## **ADDENDUM #2**

### **Rye City School District**

***Issued: 2021-02-05***

**This Addendum No. 2 forms part of the Contract Documents and modifies the original bidding documents dated, January 19, 2021.**

SEAL & SIGNATURE DATE: 11/07/19  
PROJECT No: 9200  
DRAWING BY: BGA  
CHK BY: BGA  
DWG No: H2-202

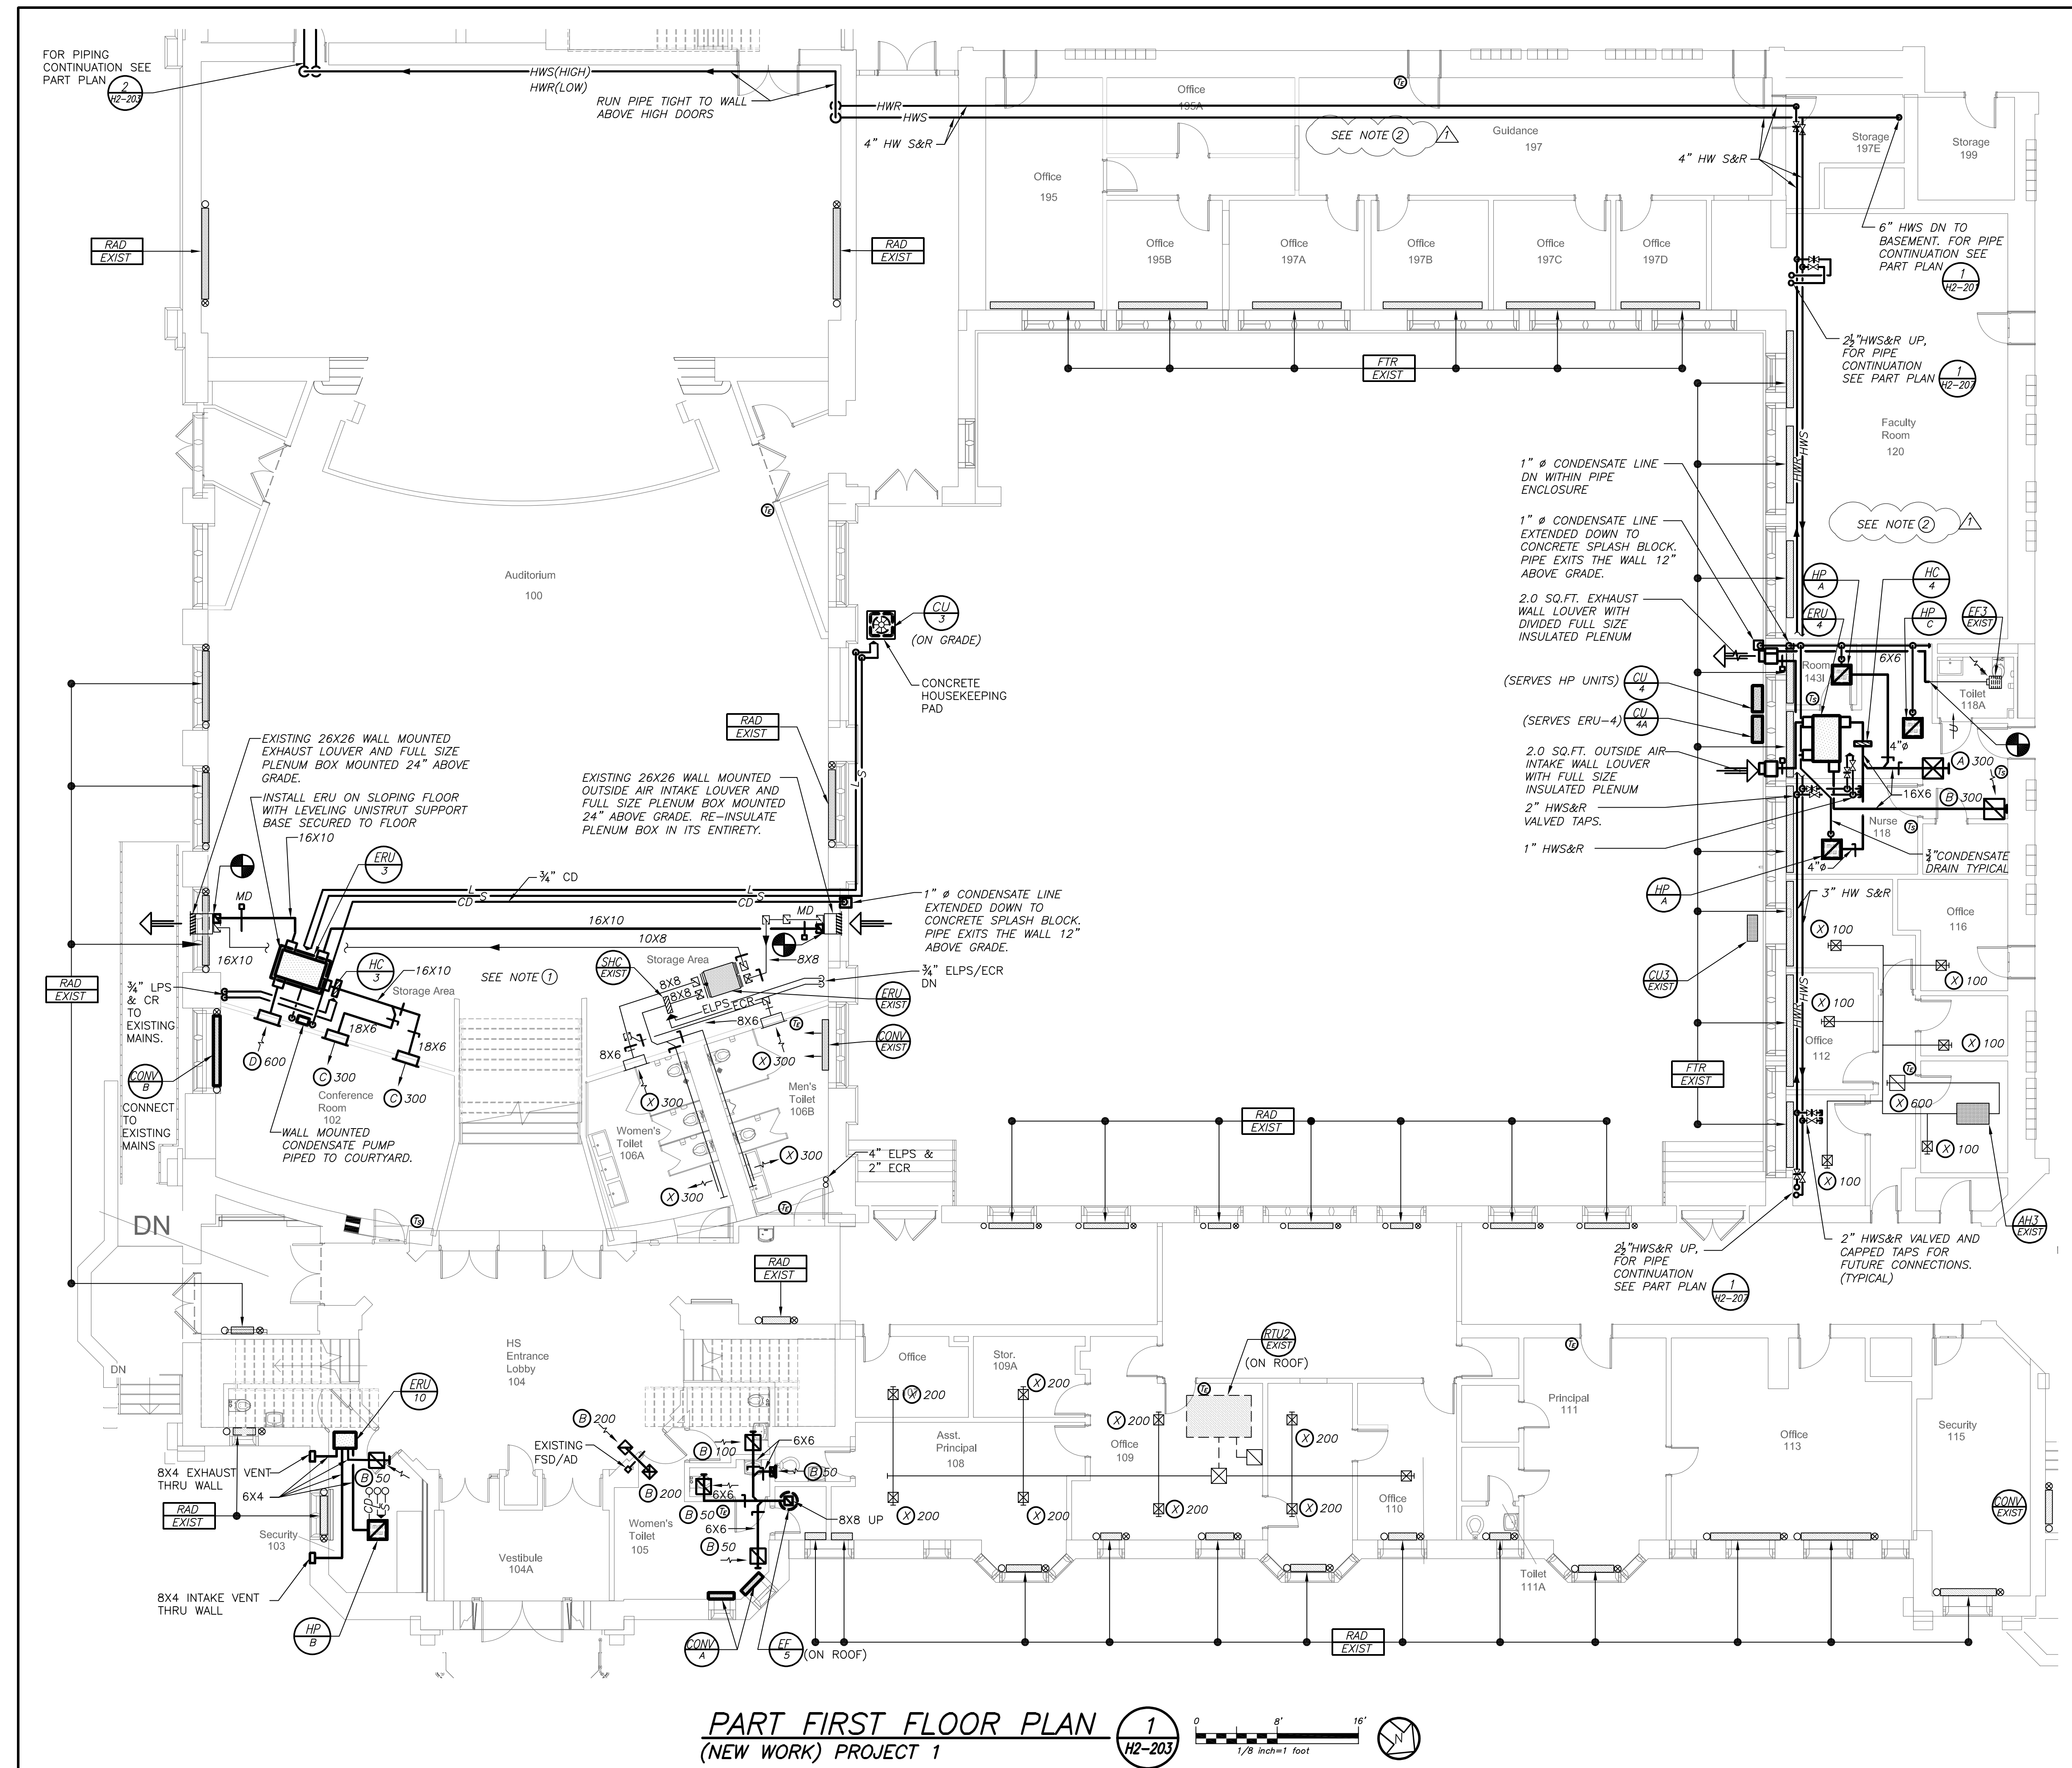
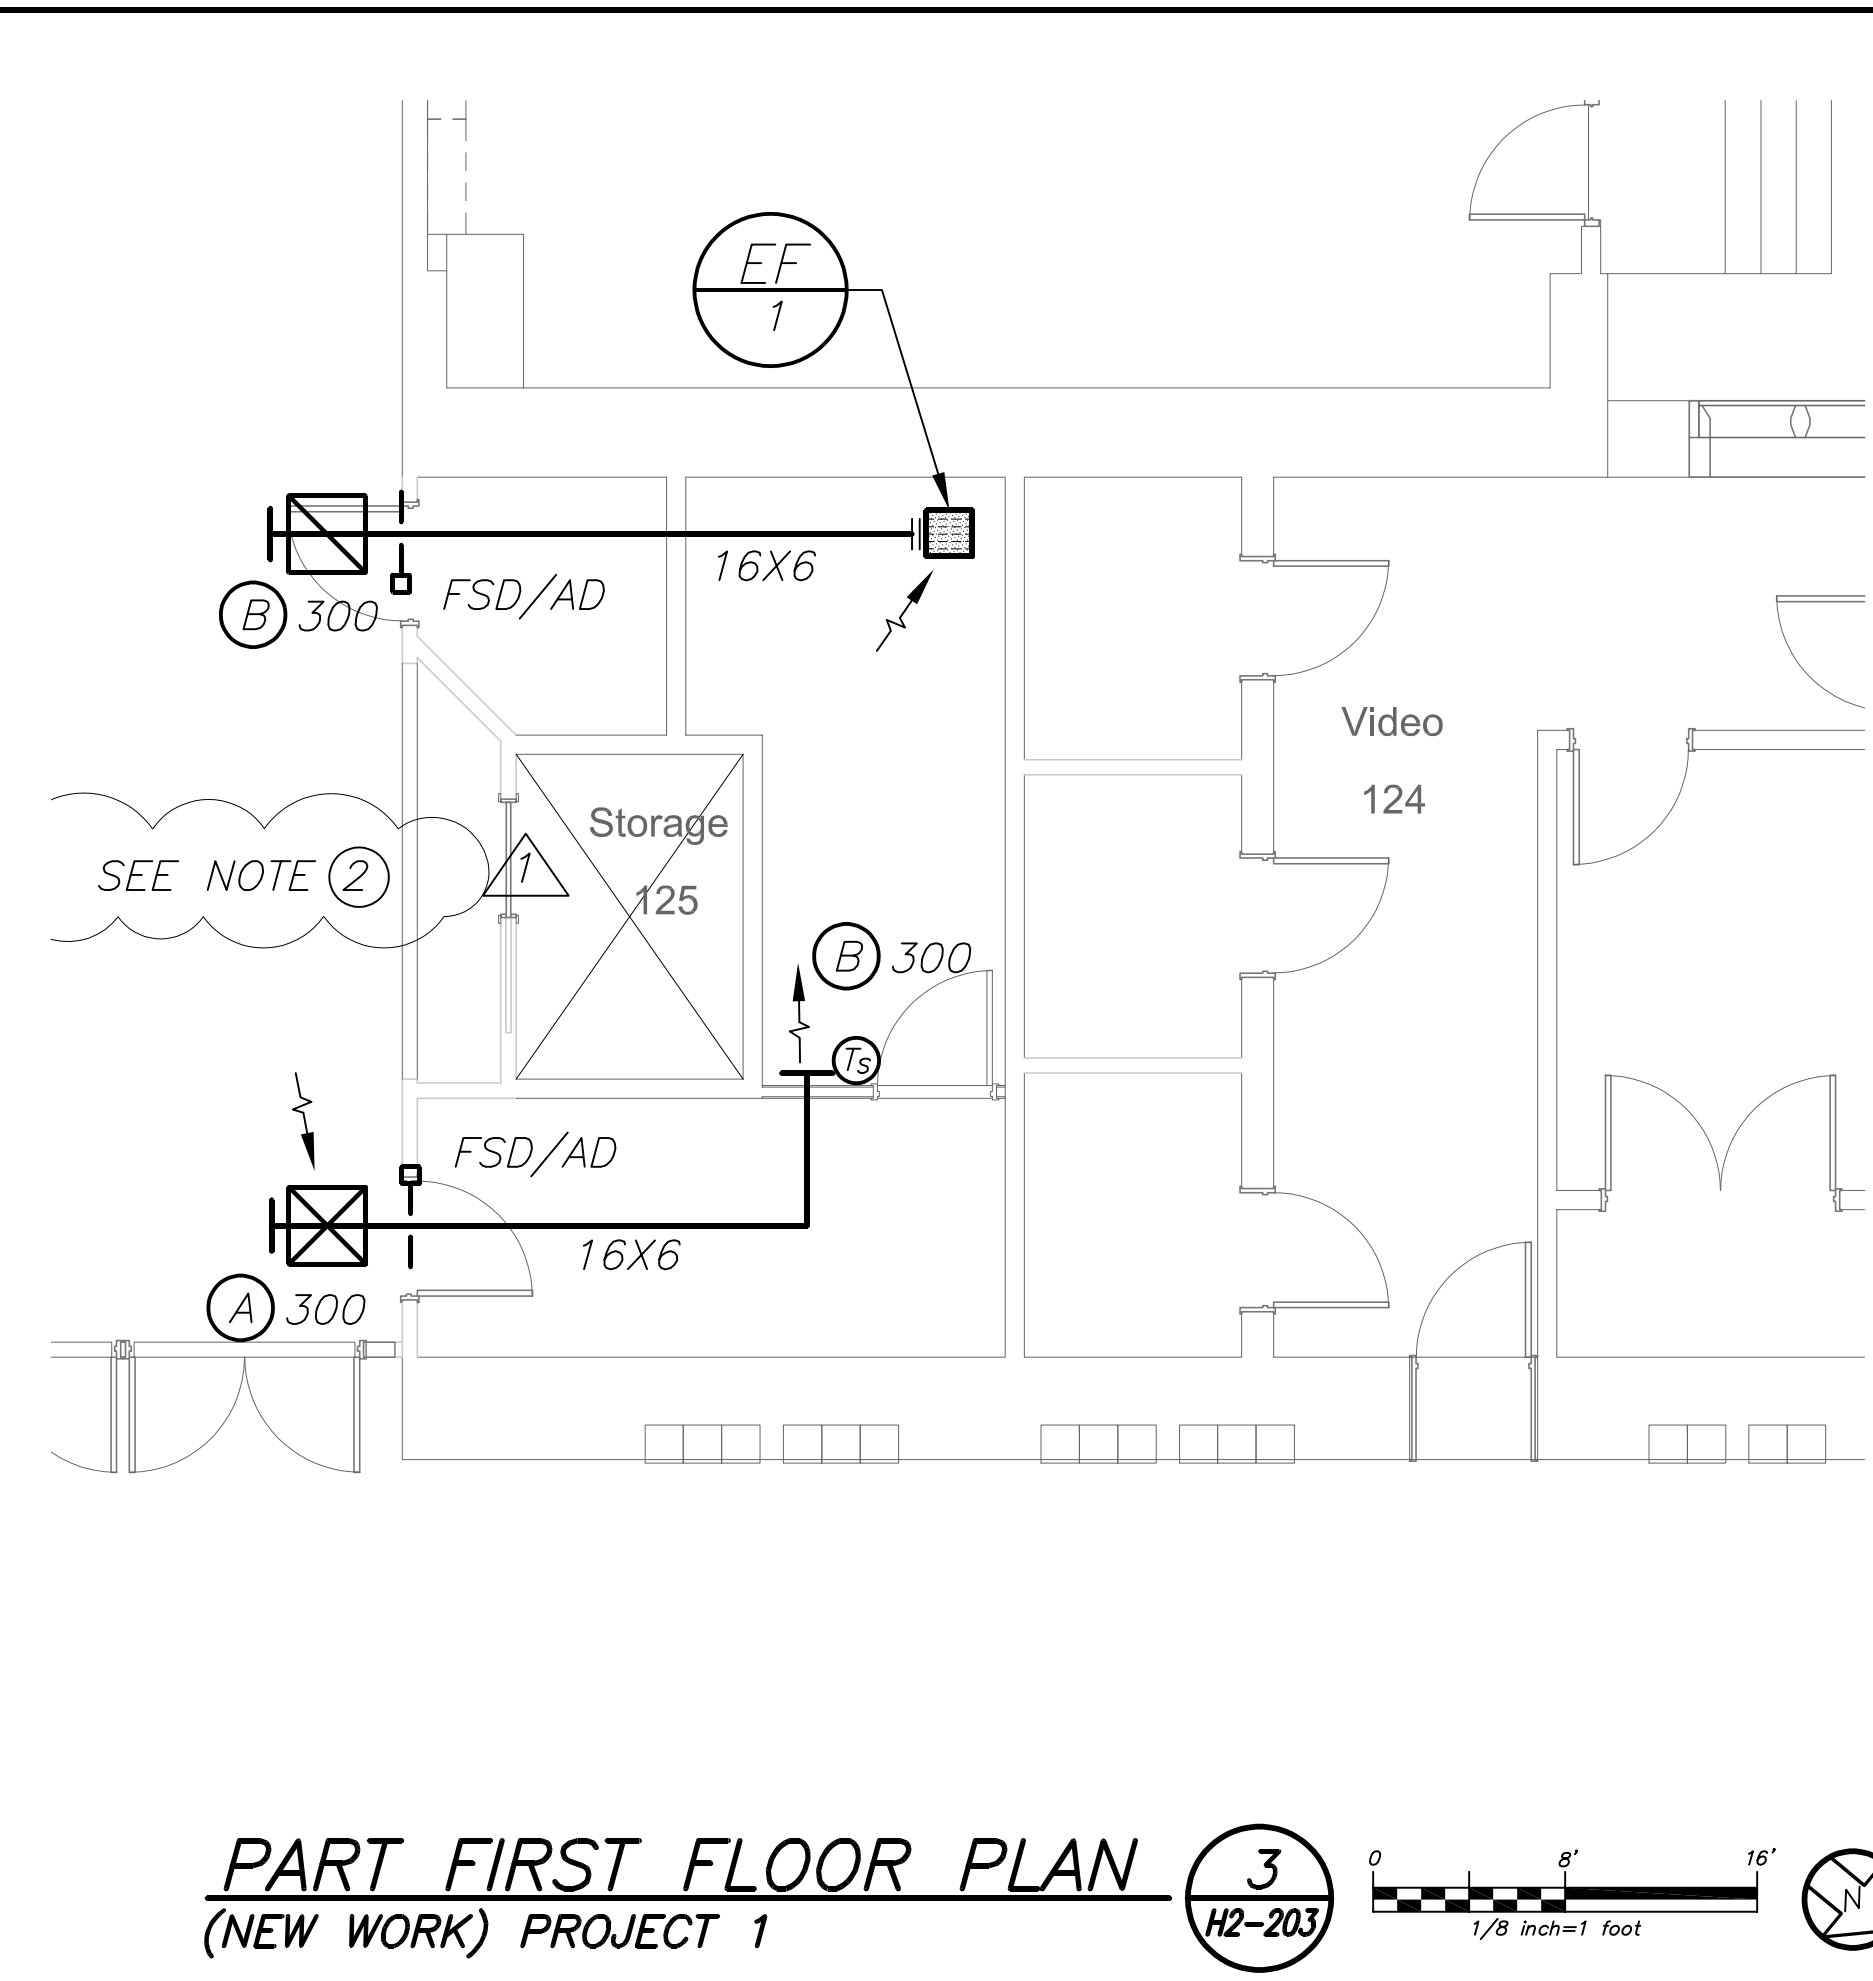
- a. Add reference to “See note 1” to indicate areas of ceiling work by HVAC contractor where not indicated as being replaced in architectural drawings.

**SKP2-1**

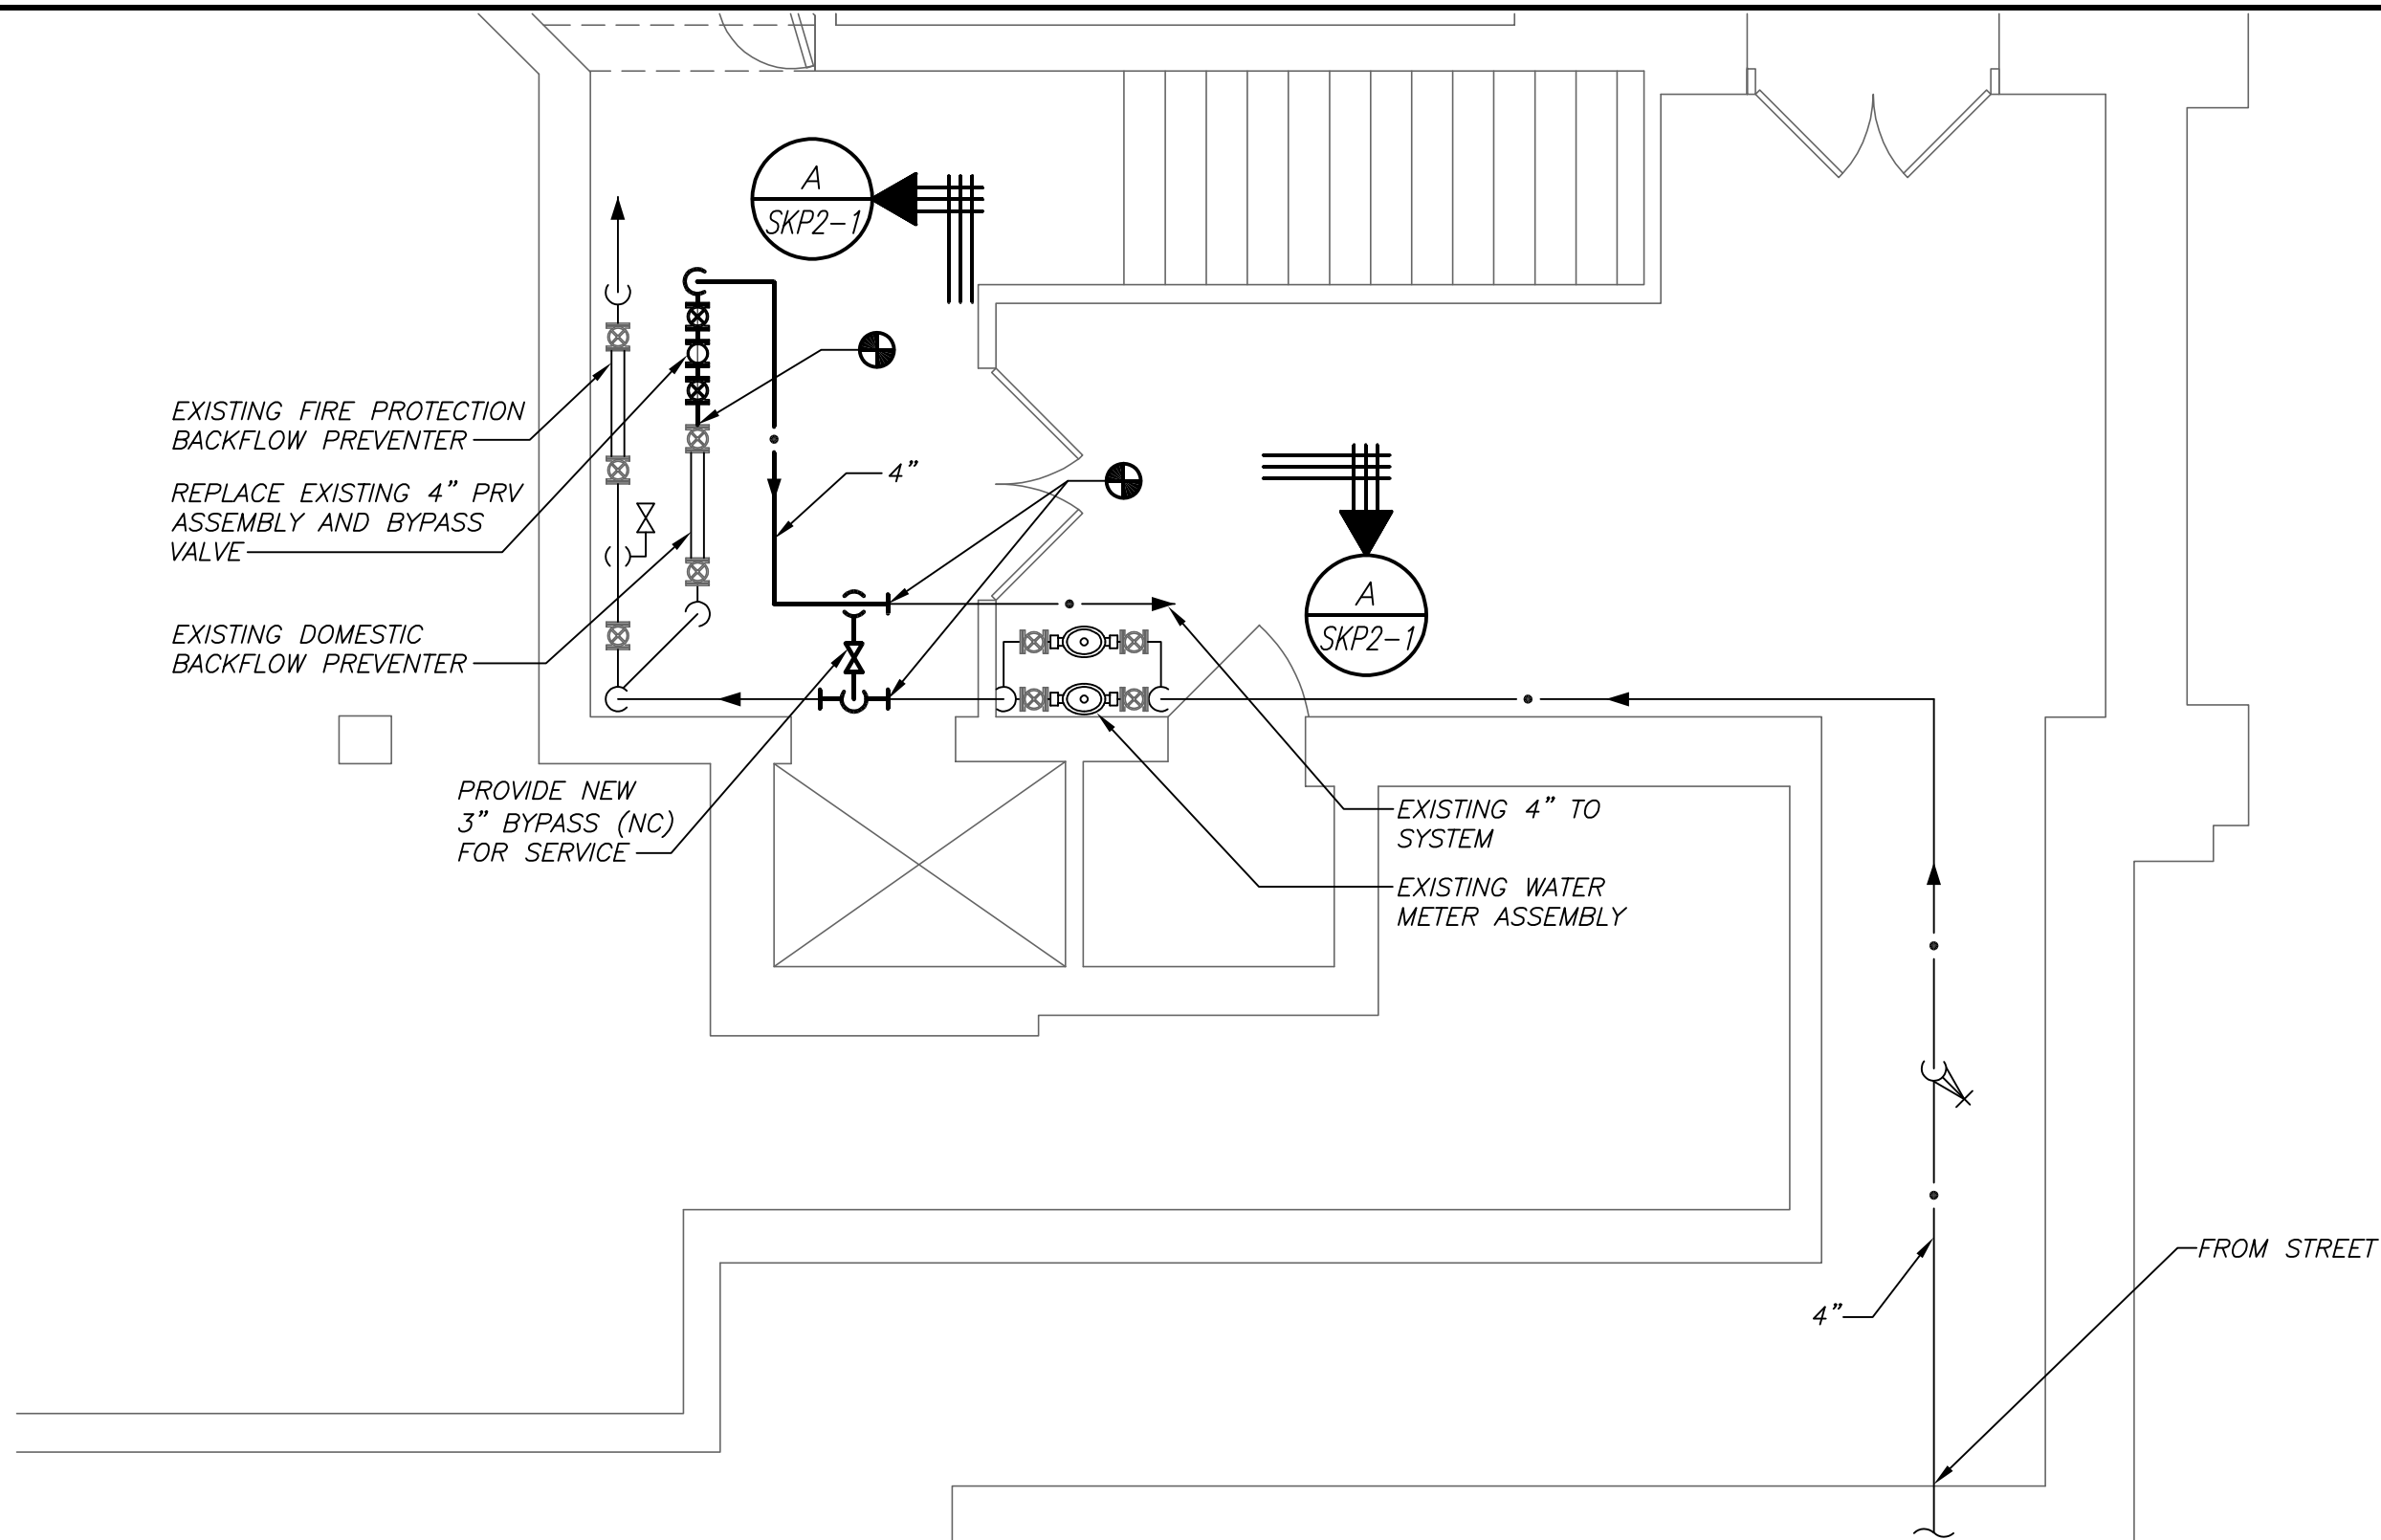
1. Drawing P2 – 101 Legend, Schedules, Notes, First and Second Floor Plans
  - a. Second Floor Plan 2/P2-101 (Removals) (Project 1).
    - i. Add note: “Included sink removal in Room 221A for second new electric room.”
2. Sketches SKP2-1 and SKP2-2
  - a. PRV Assembly Replacement as shown on sketches attached.
